February 27, 2015
RC-15-0030

Subject: VIRGIL C. SUMMER NUCLEAR STATION (VCSNS) UNIT 1
DOCKET NO. 50-395
OPERATING LICENSE NO. NPF-12
SOUTH CAROLINA ELECTRIC & GAS COMPANY'S FOURTH SIX-MONTH
STATUS REPORT IN RESPONSE TO MARCH 12, 2012 COMMISSION ORDER
MODIFYING LICENSES WITH REGARD TO REQUIREMENTS FOR
MITIGATION STRATEGIES FOR BEYOND-DESIGN-BASIS EXTERNAL
EVENTS (ORDER NUMBER EA-12-049) (TAC NO. MF2338)

**SOUTH CAROLINA ELECTRIC & GAS COMPANY'S FOURTH SIX-MONTH STATUS
REPORT FOR THE IMPLEMENTATION OF ORDER EA-12-049, ORDER MODIFYING
LICENSES WITH REGARD TO REQUIREMENTS FOR MITIGATION STRATEGIES
FOR BEYOND-DESIGN-BASIS EXTERNAL EVENTS**

CONCEPTUAL SKETCHES OF STRATEGIES

Figure 1 – Conceptual Phase 1&2 Coping for SG Feed Makeup

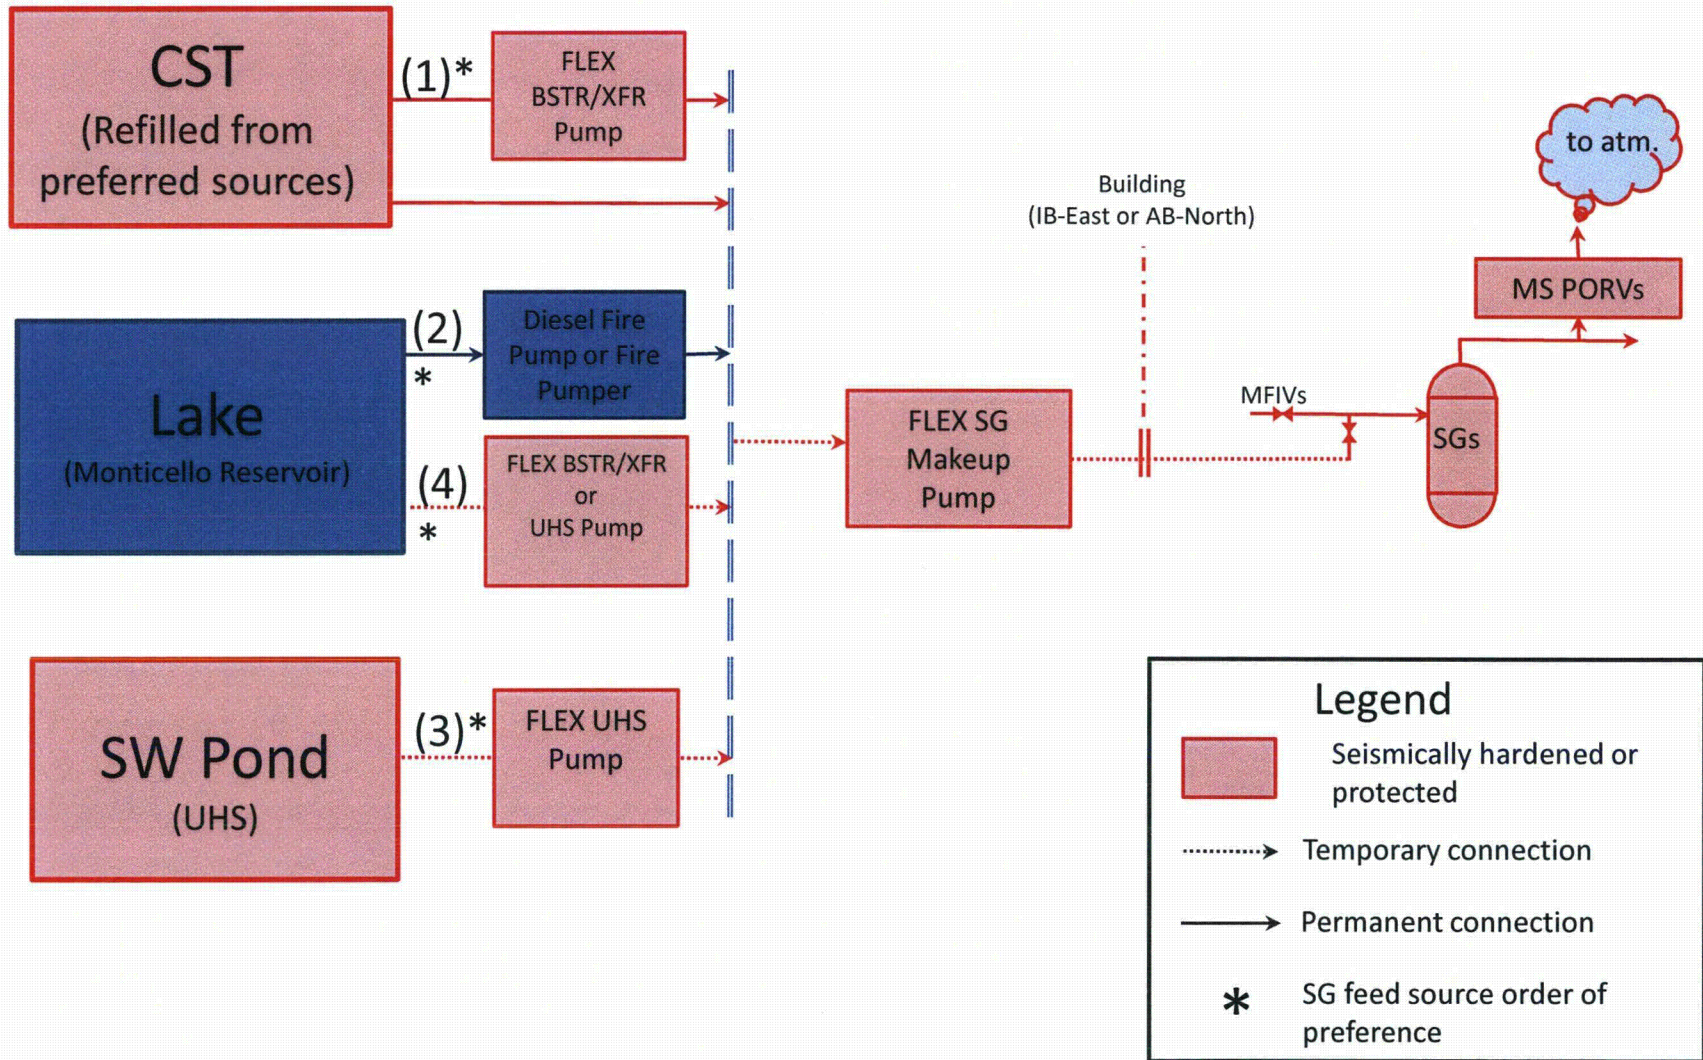
Figure 1 – Conceptual Phase 1&2 Coping for SG Feed Makeup was revised and reissued in Attachment II of this submittal. The pumps for taking suction from the Lake were revised to include the FLEX UHS Pump.

Figure 2 – Conceptual Diverse Strategy for Supplying FLEX SG Makeup Pump

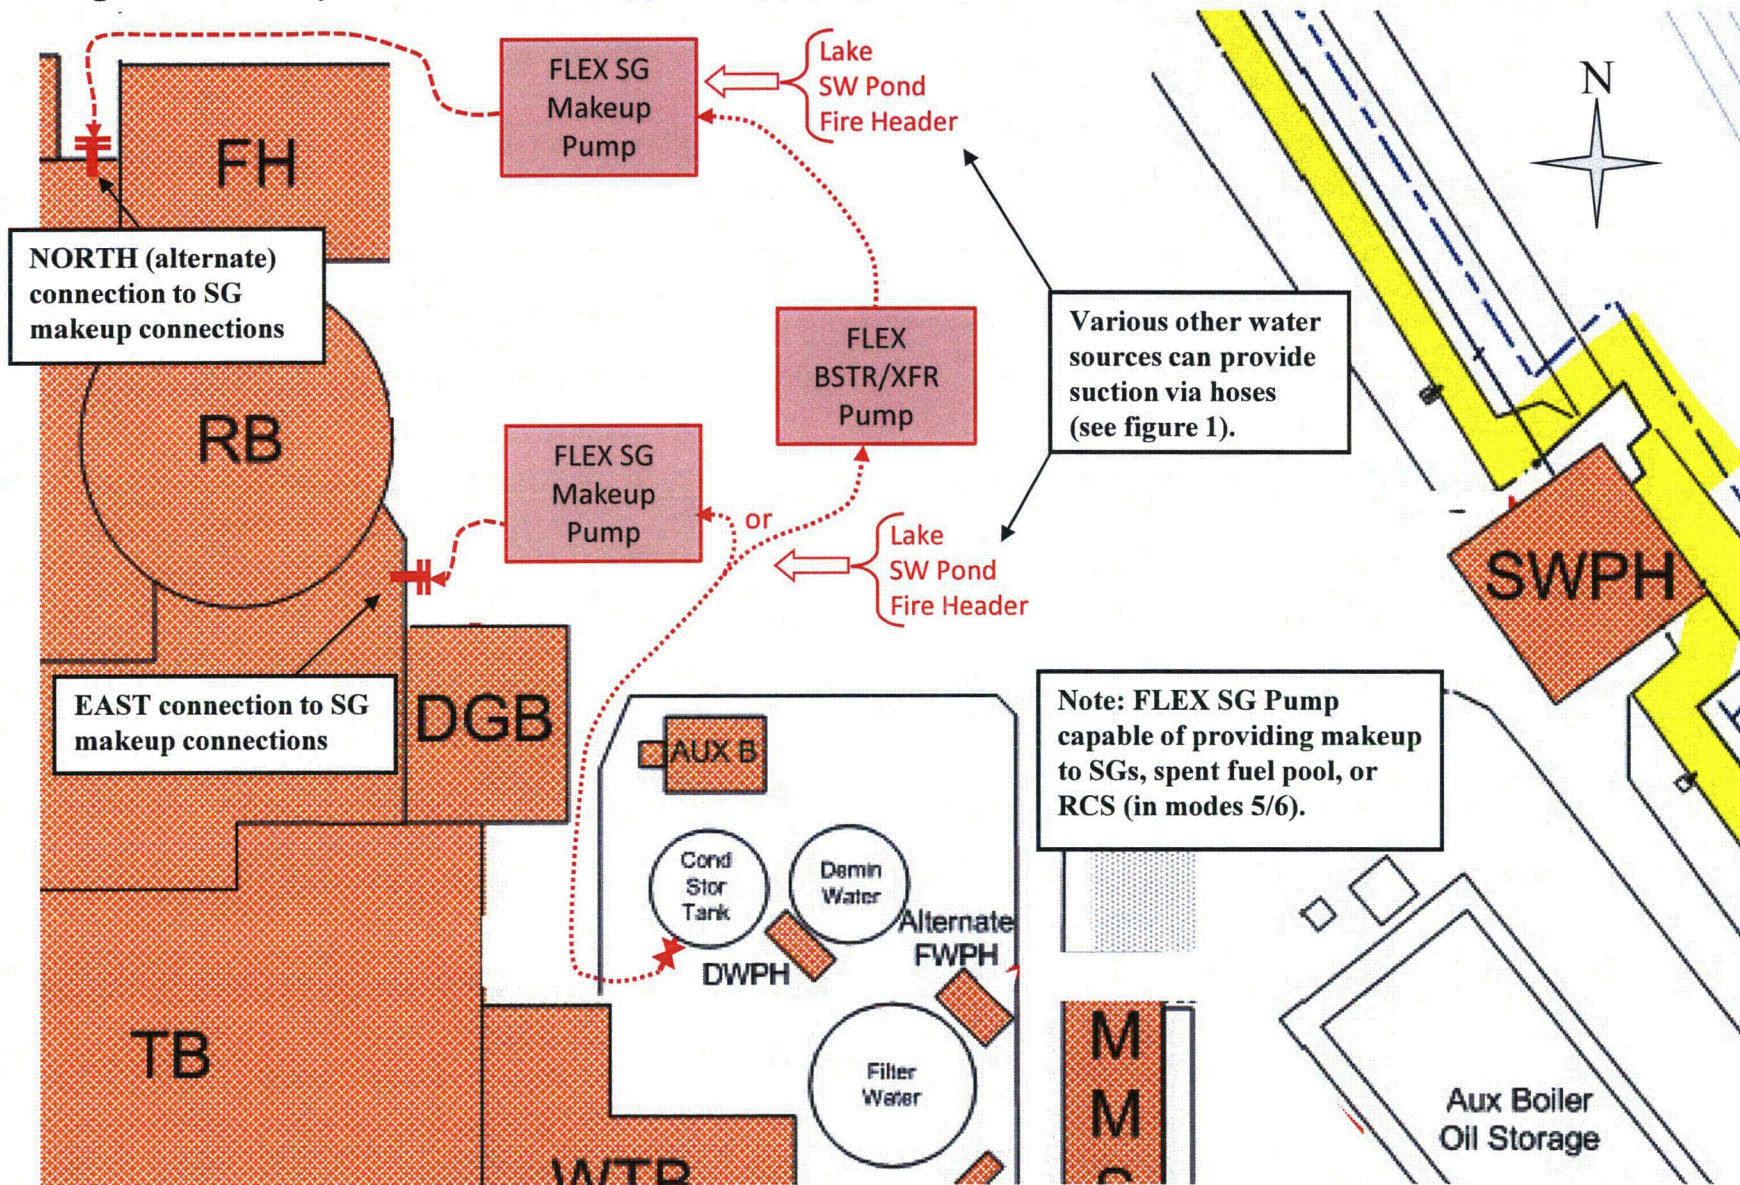
Figure 2 – Conceptual Diverse Strategy for Supplying FLEX SG Makeup was revised and reissued in Attachment II of this submittal. The location and configuration of the FLEX Booster/Transfer Pump was revised to reflect its purpose to provide net positive suction head (NPSH) to the North FLEX SG Makeup pump.

Figure 3 – Conceptual Phase 2 Coping for Refilling of CST

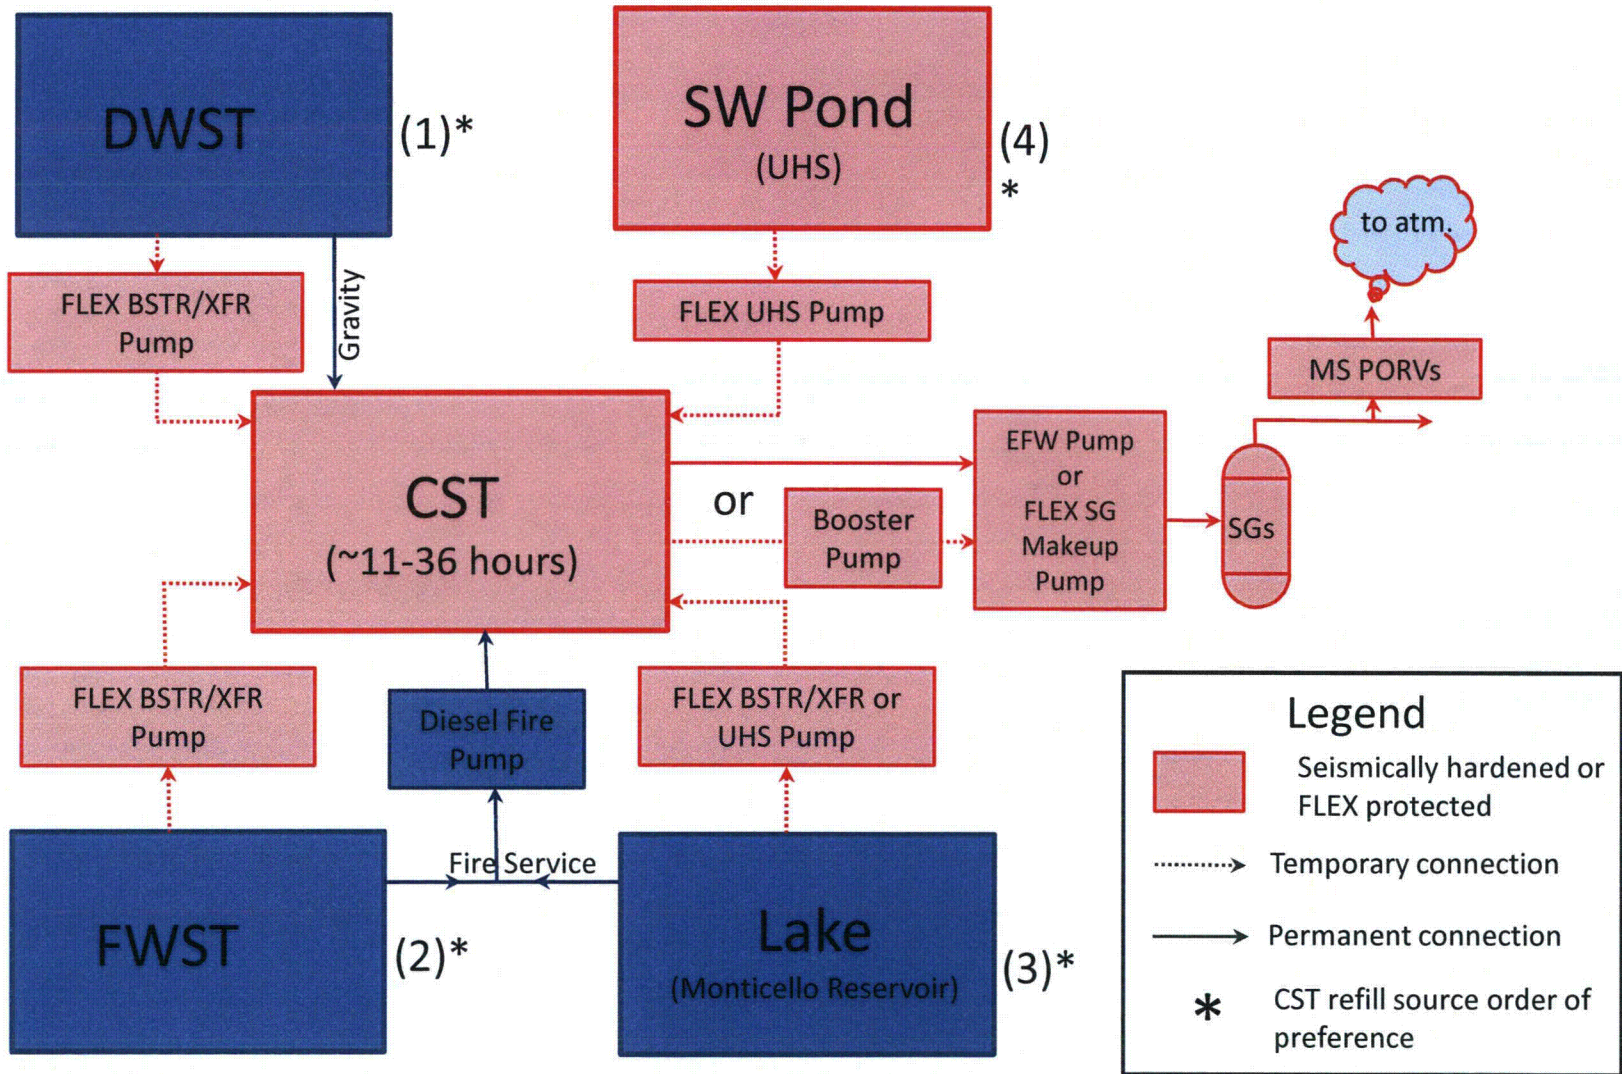
Figure 3 – Conceptual Phase 2 Coping for Refilling of CST was revised and reissued in Attachment II of this submittal. The pumps for taking suction from the Lake were revised to include the FLEX UHS Pump and the Booster pump was renamed the BSTR/XFR Pump.

Figure 8 – Conceptual FLEX Feed Hose Layout

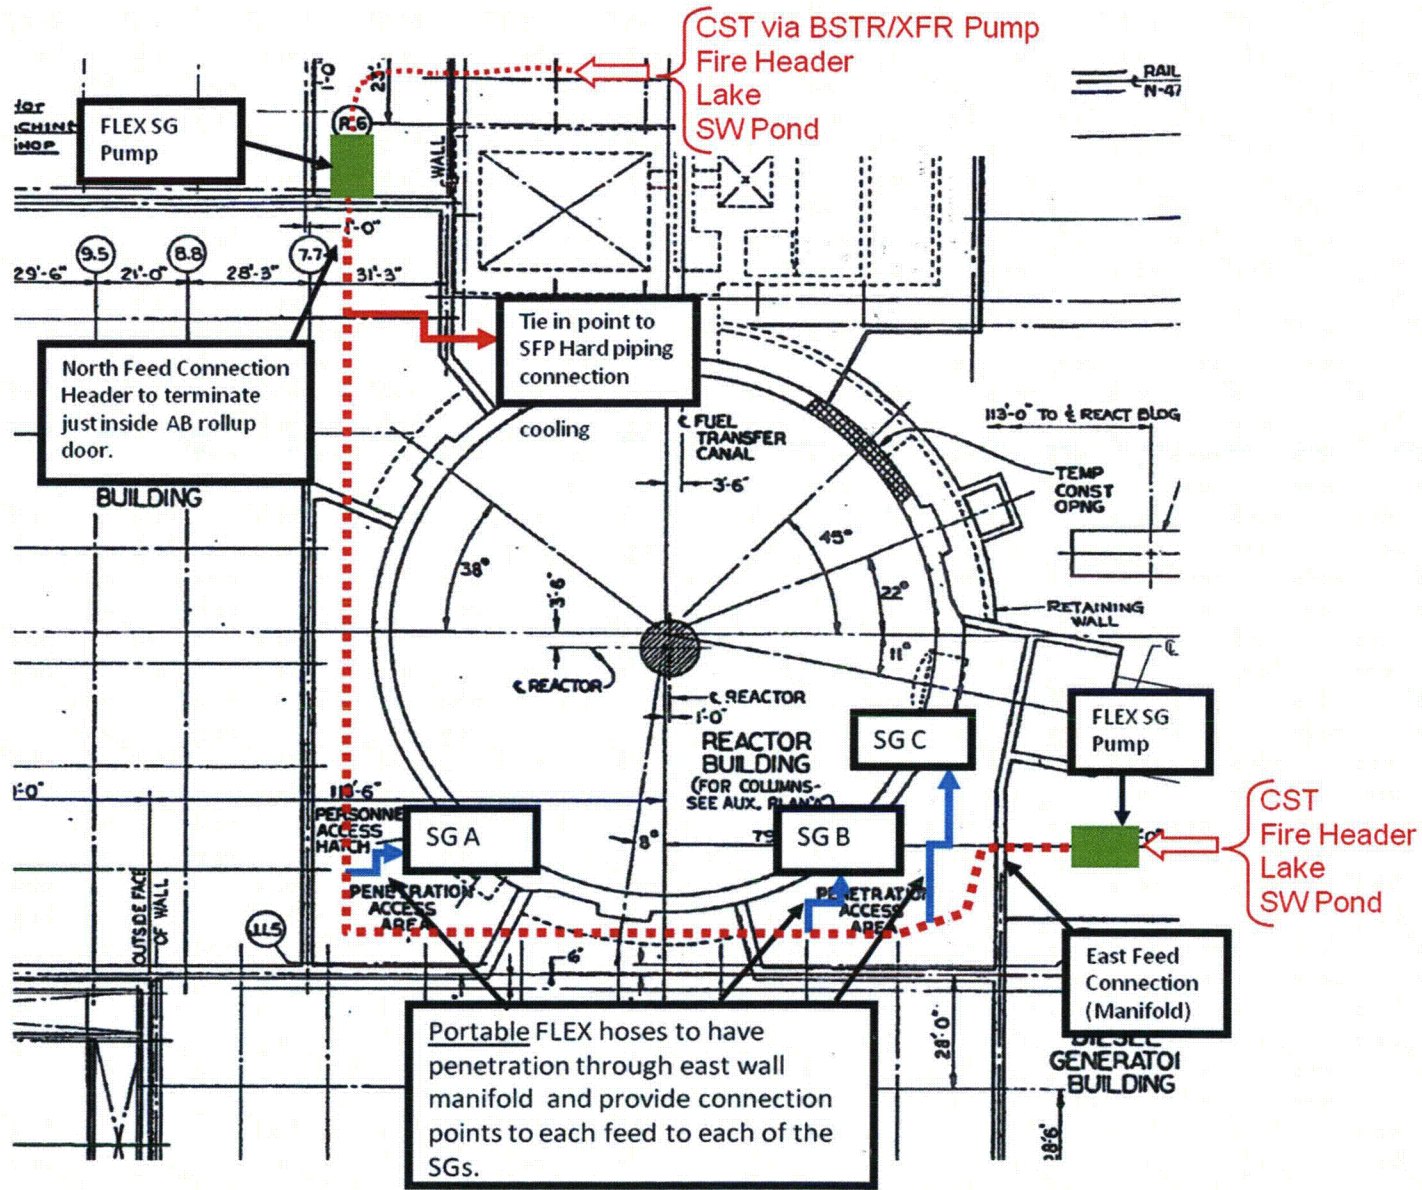
Figure 8 – Conceptual FLEX Feed Header Layout was renamed **Conceptual FLEX Feed Hose Layout** and reissued in Attachment II of this submittal.

Figure 11 – FLEX Strategy Conceptual Mechanical Diagram

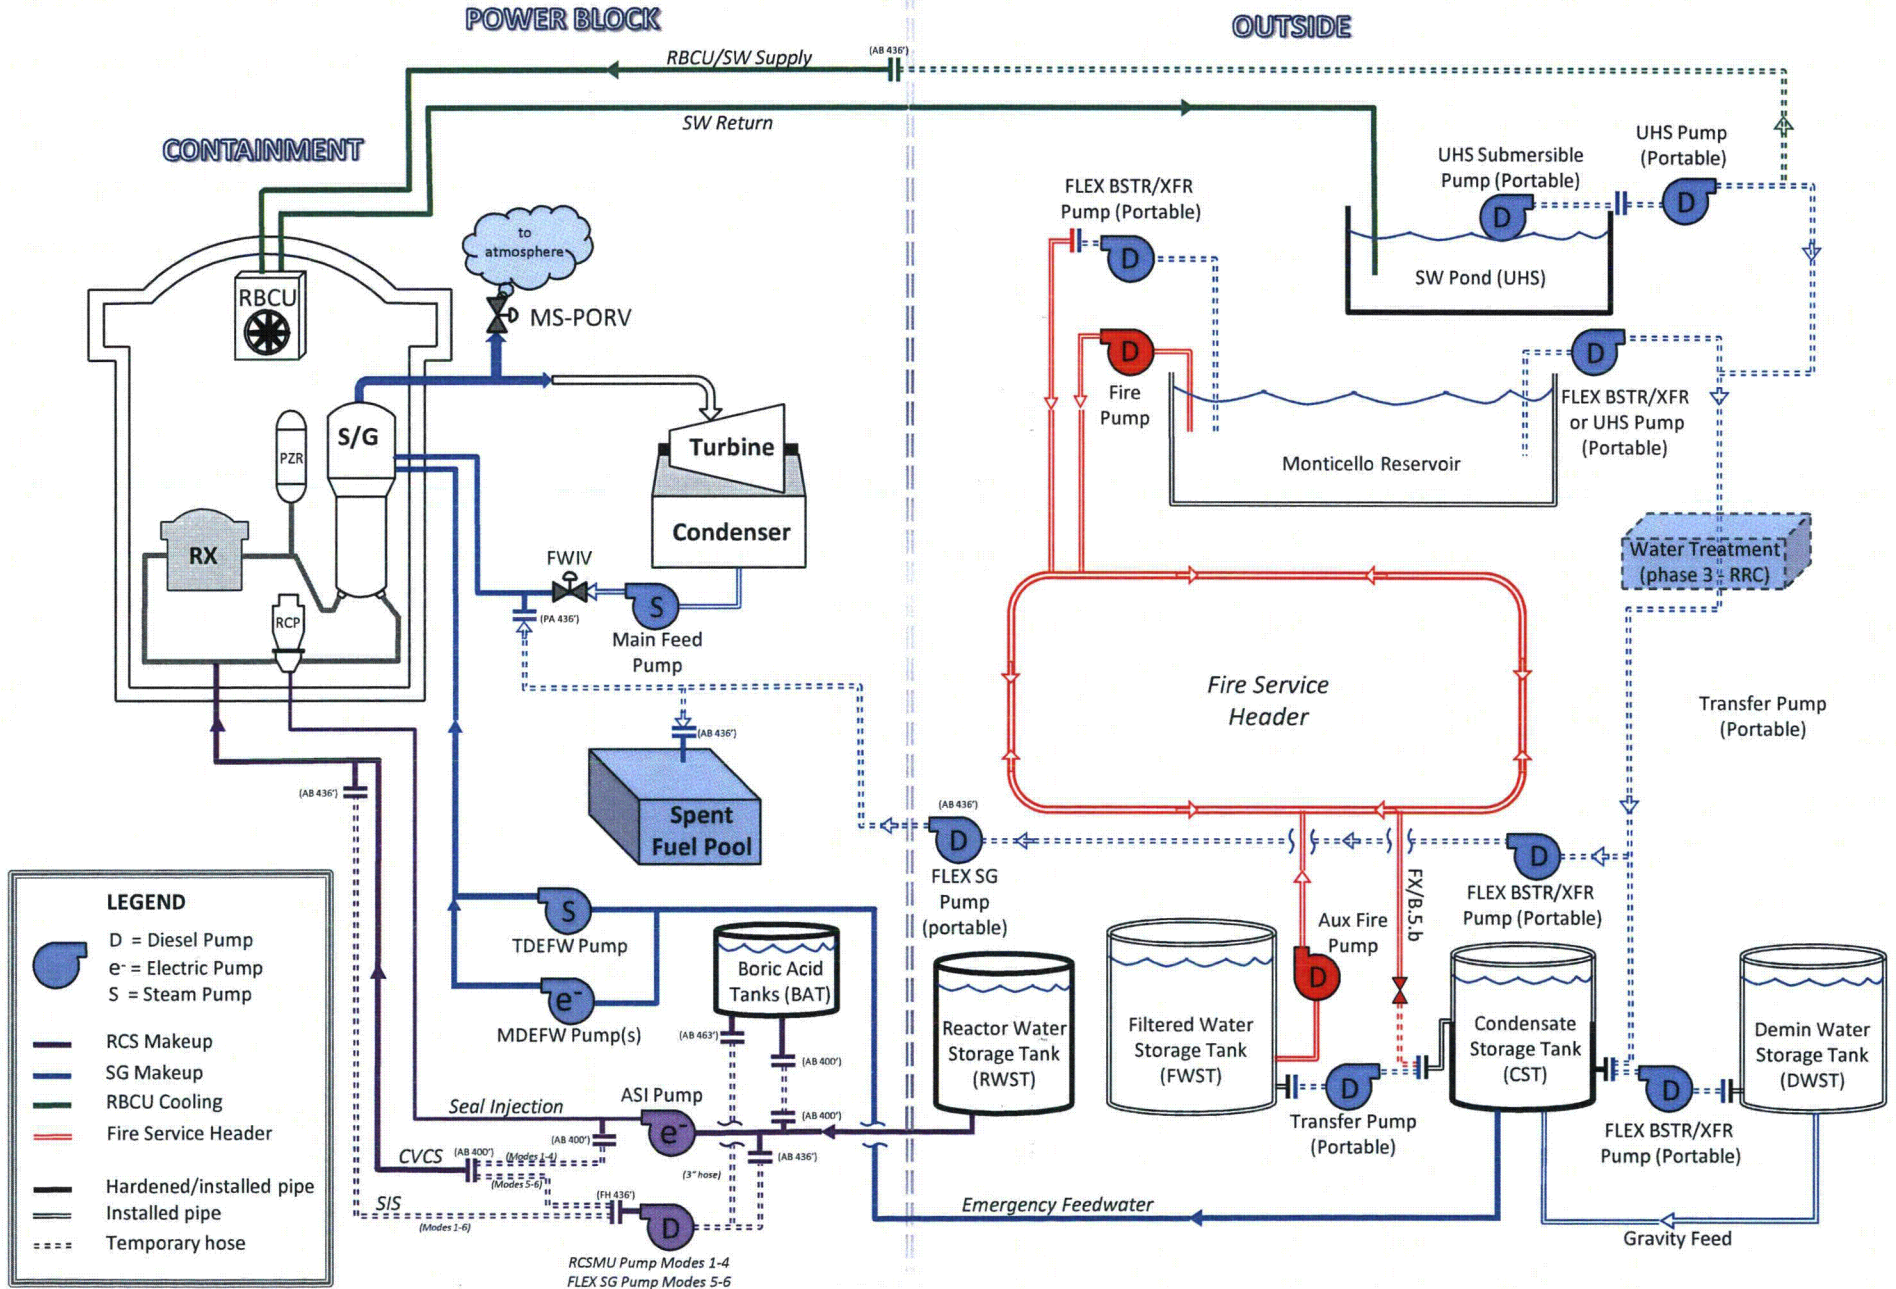
Figure 11 – FLEX Strategy Conceptual Mechanical Diagram was revised to identify RCS Makeup methods for Modes 1-4 and Modes 5-6.
